ST. TAMMANY PARISH

Addendum No.: 1

Bid#: 20-6-2

Project Name: I-10 Service Road Bridge Replacements

SECTION A-A
SCALE 3/8" = 1'-0"

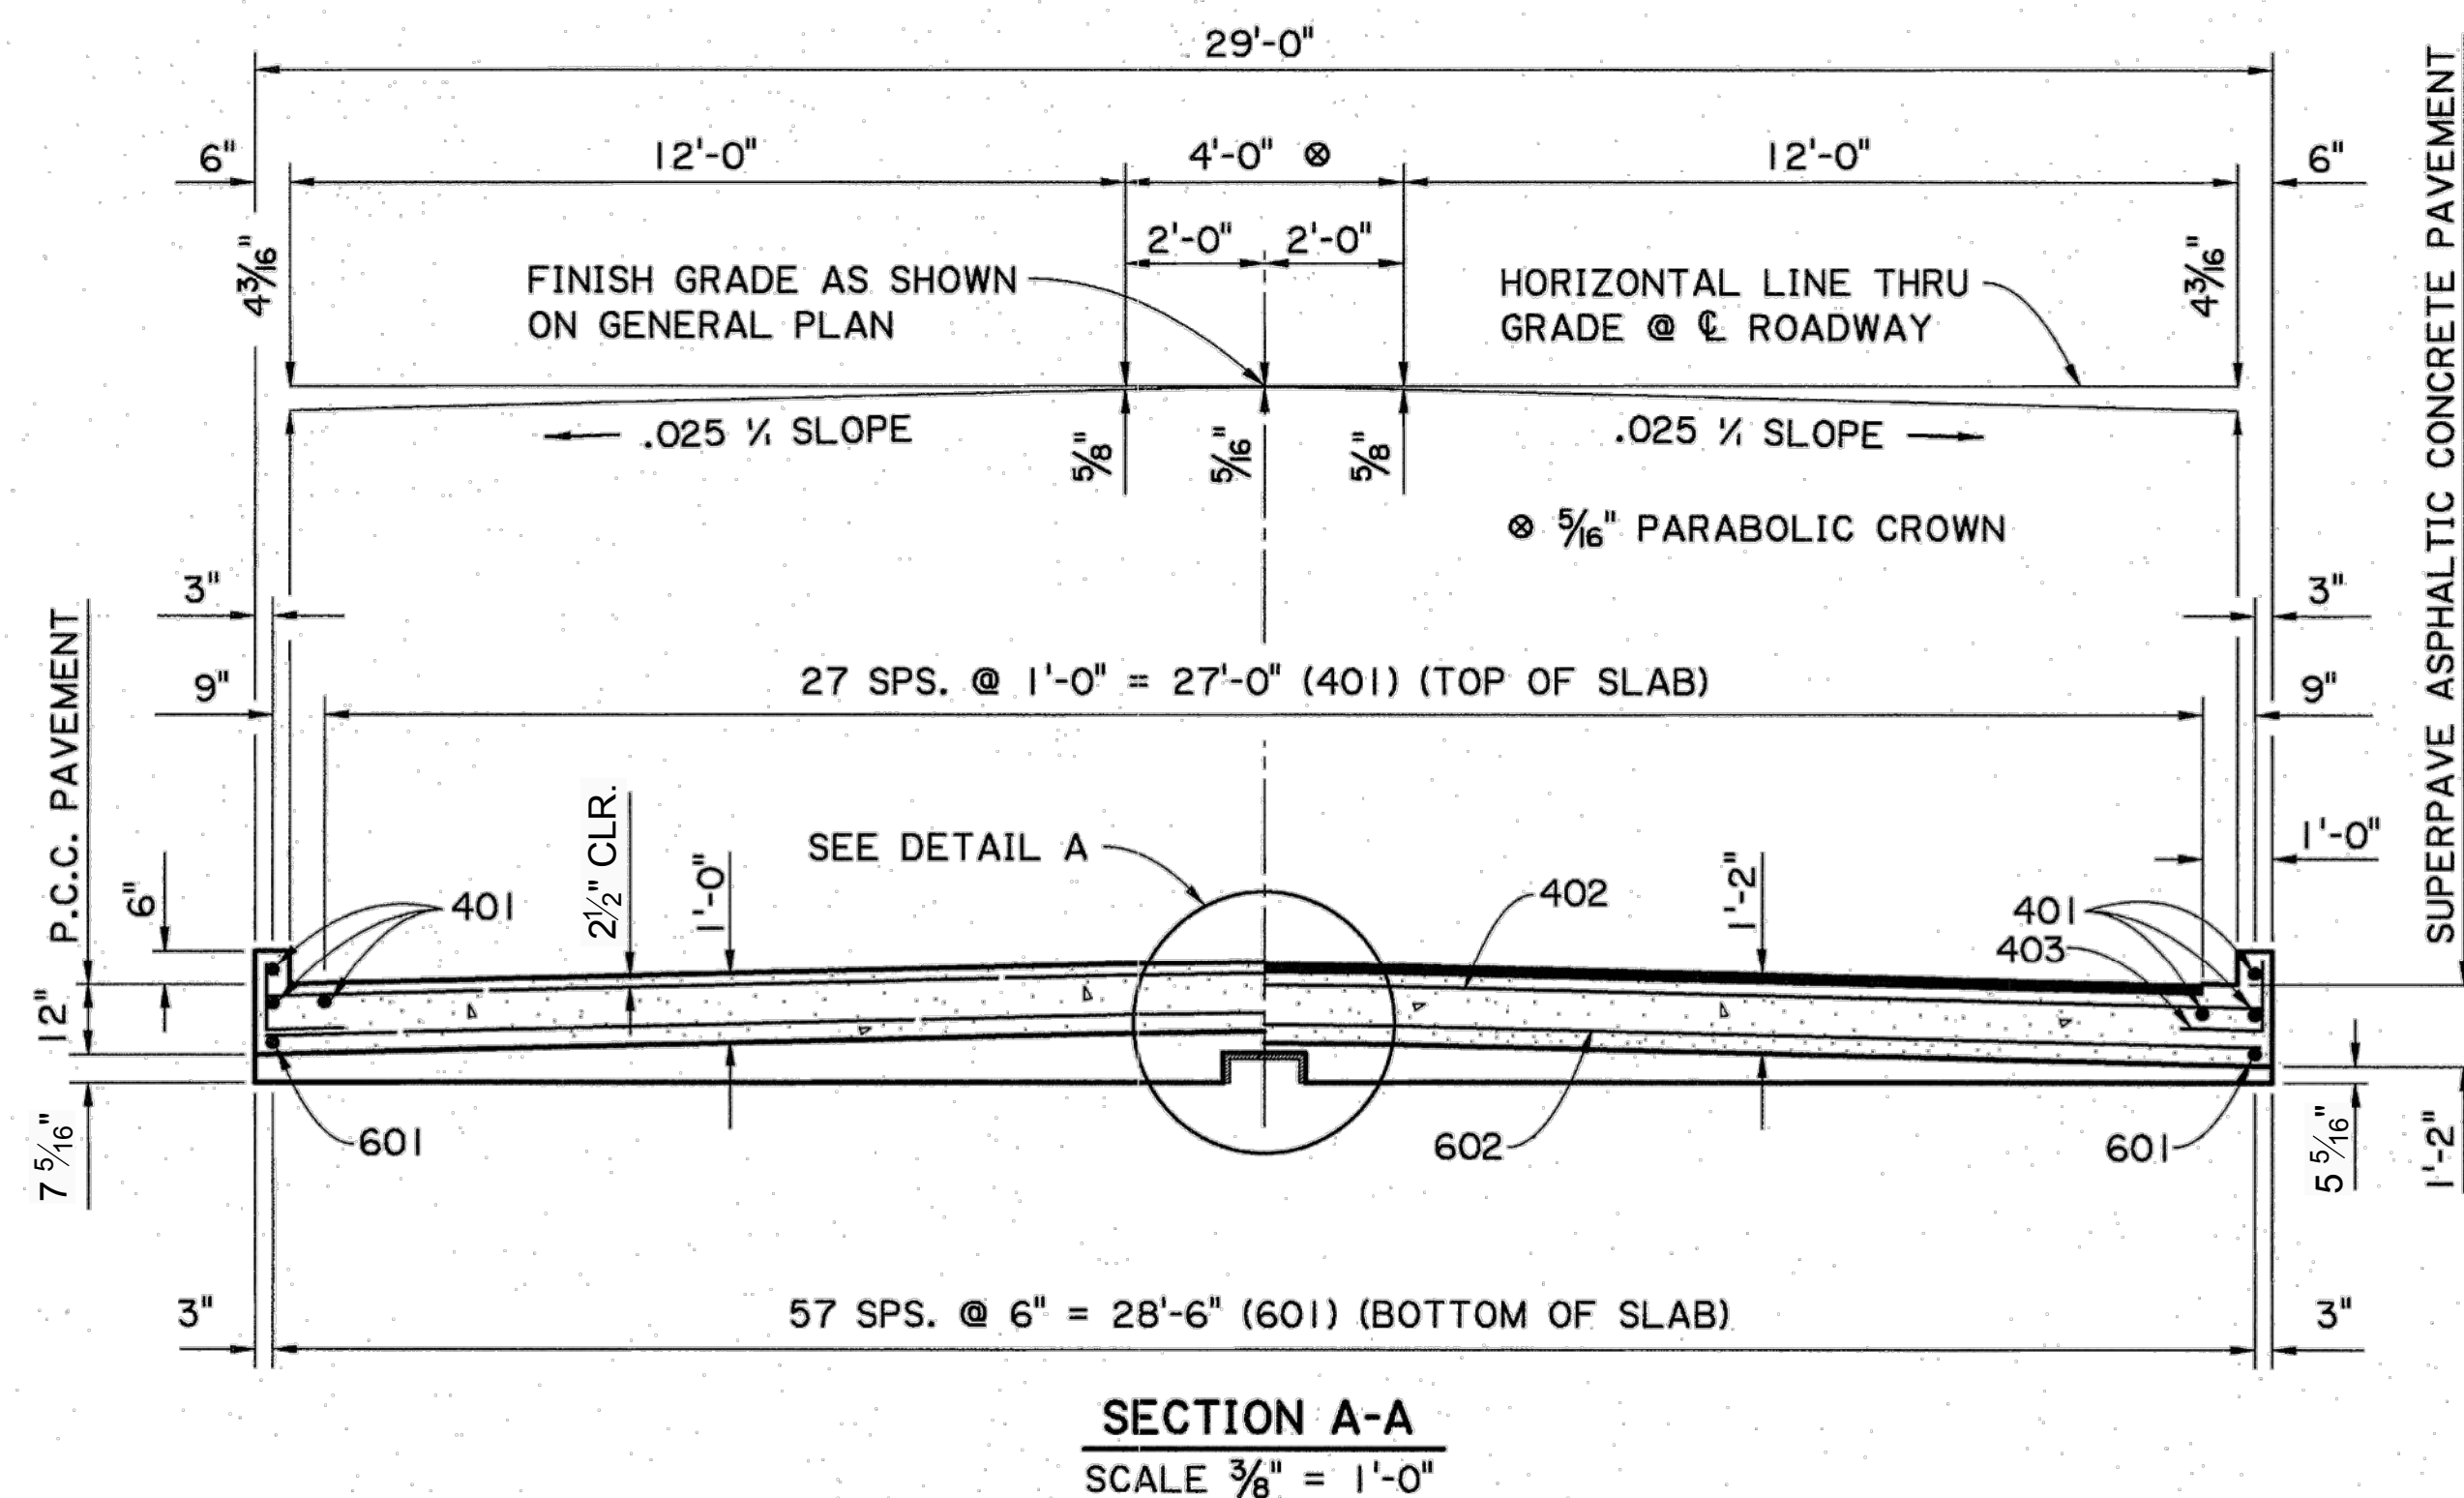
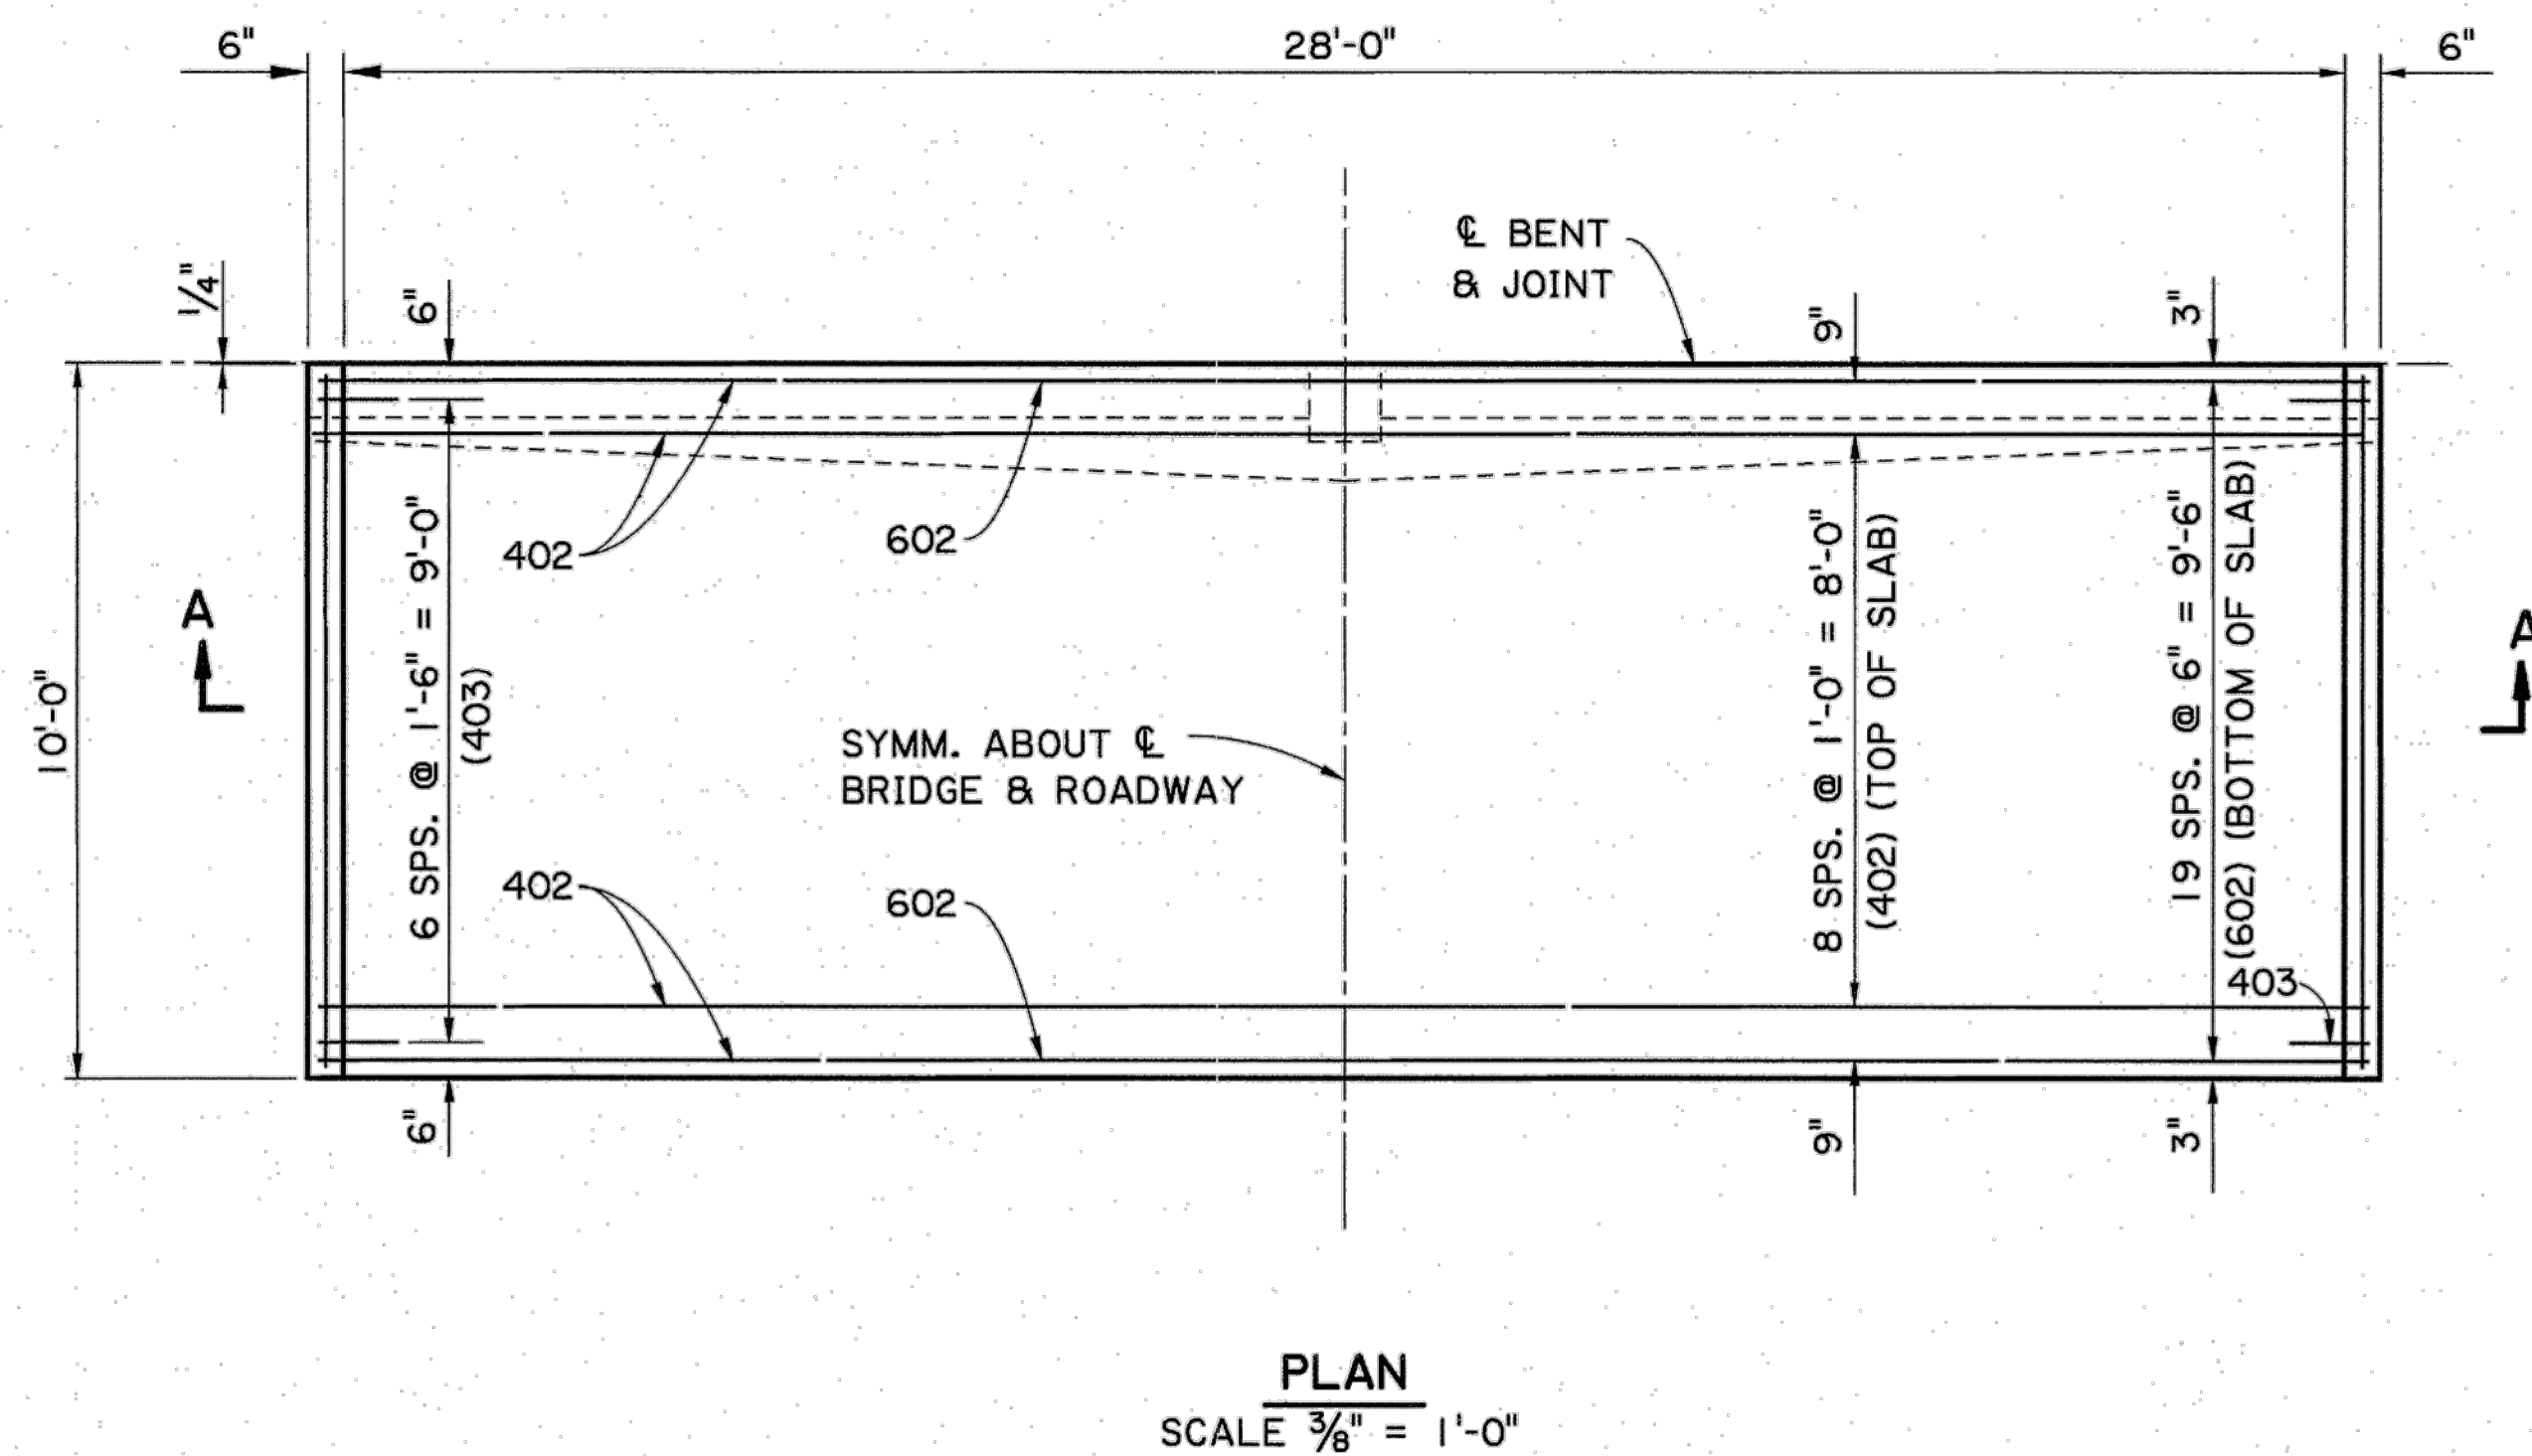
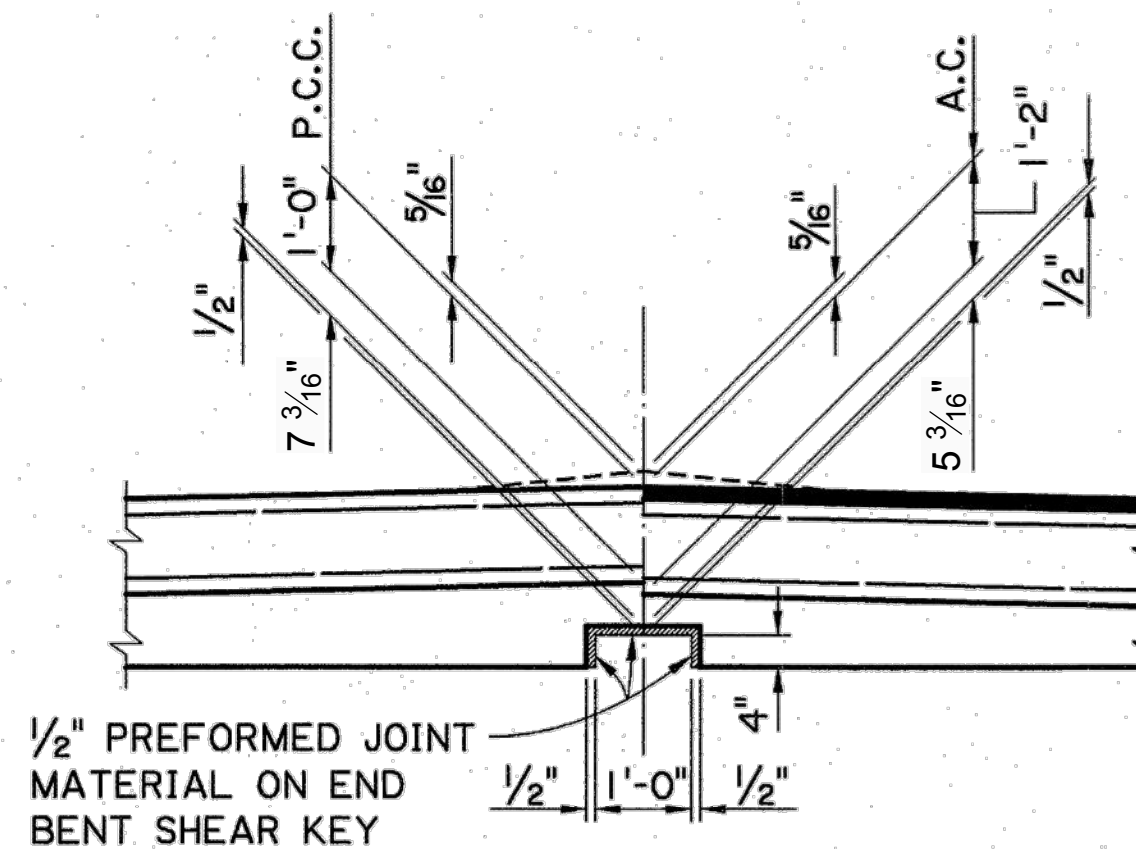
Question 8: This project references 2016 LA DOTD Specs but the approach slab seems to follow the 2006 Specs, will the approach slab require a sleeper slab and bearing pads? Or is it to be as show on plan sheet 106 & 110?

Answer 8: See the attached Plan Sheets 110, 106 and 341 in regards to this question.
